Access Compliance Report

Public Rights-of-Way

(Curb Ramps)

Intersection ID: 54455	Main Street: COLLINGHAM_DR	Cross Street: RUPELL_DR	Location: SW
ADA ID: 1F1C6CD45468	Ramp Type: BlendTrans1	Initial Pass/Fail: Fail	Overall Compliance: No
		Severity Score: 12.5

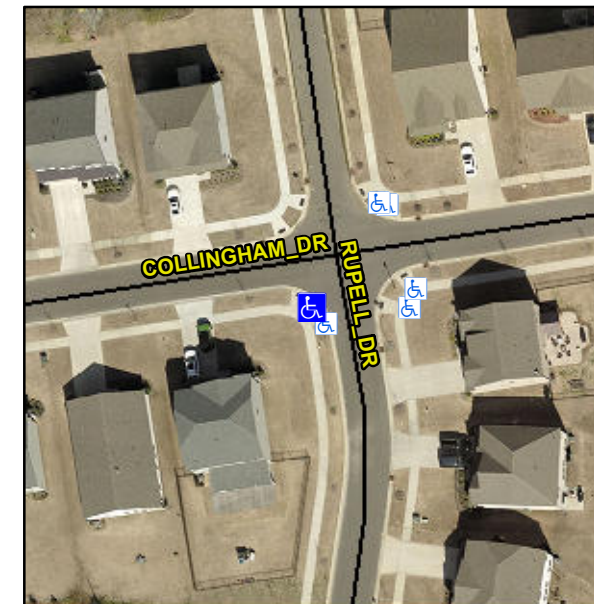
Not Found, R304.5.3

Compliance	Description	Data	Compliance	Description	Data
N/A	Ramp Length (in)	95.0	Yes	BlendTrans Slope (%)	0.2
Yes	Ramp Width (in)	48.0	No	BlendTrans XSlope (%)	5.2
N/A	Flare Type LT	N/A	N/A	Flare Type RT	N/A
N/A	Flare Slope LT (%)	N/A	N/A	Flare Slope RT (%)	N/A
N/A	Flare Traversable LT?	N/A	N/A	Flare Traversable RT?	N/A
N/A	Landing Length (in)	N/A	N/A	DWS Provided?	N/A
N/A	Landing Width (in)	N/A	N/A	DWS Contrast?	N/A
N/A	Landing Slope (%)	N/A	N/A	DWS Length (in)	N/A
N/A	Landing X Slope (%)	N/A	N/A	DWS Full Width?	N/A
N/A	Landing Curb? (Y/N)	N/A	N/A	DWS Offset (in)	N/A
N/A	Shared Landing?	N/A			
N/A	Gutter Ponding?	N/A	N/A	Gutter Slope (%)	N/A
N/A	Gutter Lip Ht (in)	1.5	N/A	Gutter X Slope (%)	N/A
N/A	Painted X Walk1?	No	N/A	Painted X Walk2?	N/A
	X Walk 1 Direction	To NW		X Walk 2 Direction	N/A
	X Walk 1 Width (in)	N/A		X Walk 2 Width (in)	N/A
	X Walk 1 Slope (%)	4.1		X Walk 2 Slope (%)	N/A
	X Walk 1 X Slope (%)	0.1		X Walk 2 X Slope (%)	N/A

N/A	Ramp inside XWalk1?	N/A	N/A	Ramp inside XWalk2?	N/A
	Road Slope (%)	0.1		Clear Space?	N/A
	Road X Slope (%)	4.1	N/A	Clear Space to XWalk (in)	N/A
N/A	Any Obstructions?	N/A	N/A	Storm Grate/Utility Hazard?	N/A
	Obstruction Type			Storm Grate/Utility Type	
		N/A			N/A
			Yes	Surface Condition? (G/P)	Good
			No	Curb Slope (%)	8.2

Remove & Replace Curb Ramp With Two New Directional Ramps or Equivalent.
